RESOLUTION NO. 23-328

Subject: Seawall Repairs at 701 Palm Avenue – Change Order 1

Changer order #1

Spencer's Boat Yard

**Location Map
(Change Order work location)**

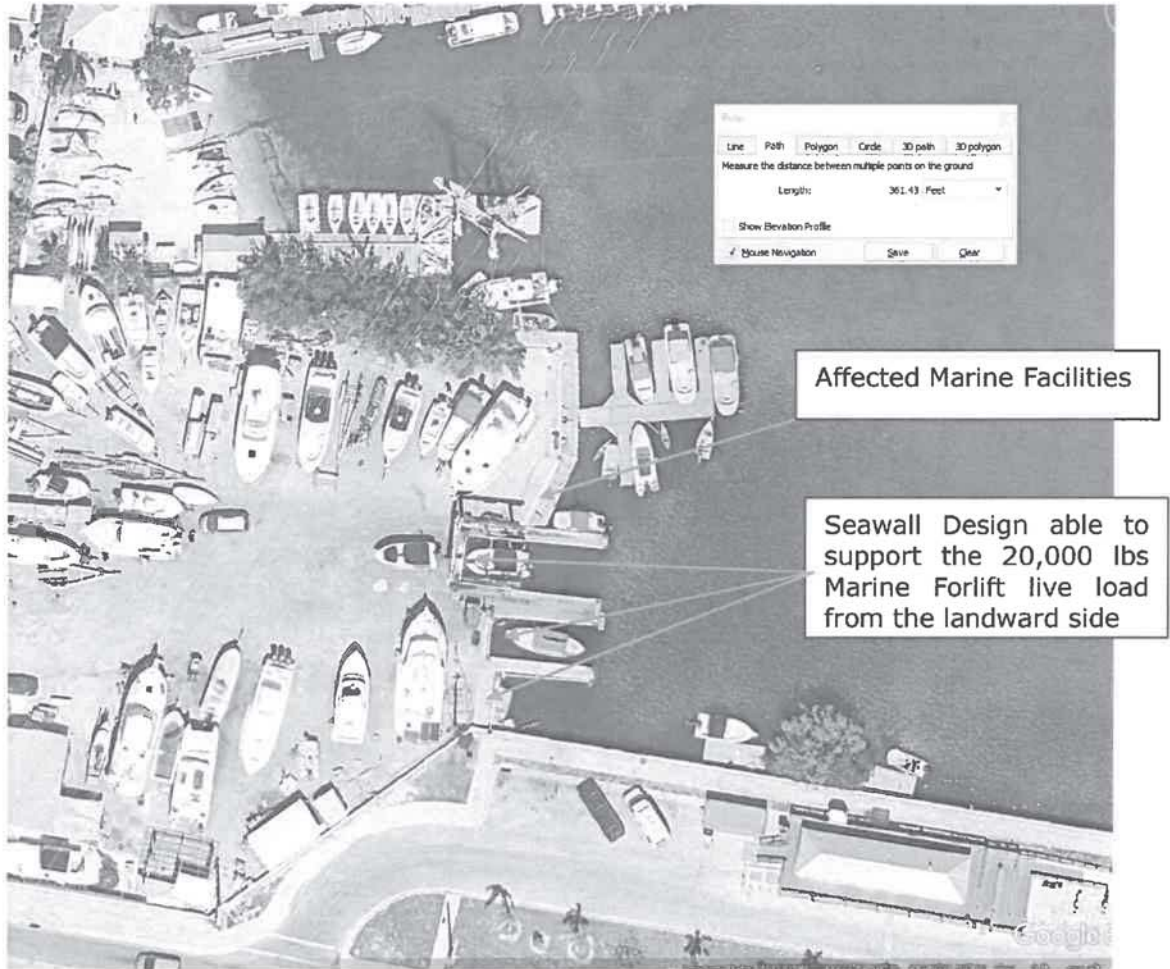
The change order is reflecting additional engineering design work associated with future live load – the Marine Forklift with the load capacity of up to 20,000 lbs able to service all three boat basins. Additional work description included and excluded items are in the Supplemental Scope of Work description by HighSpans. See Appendix B.
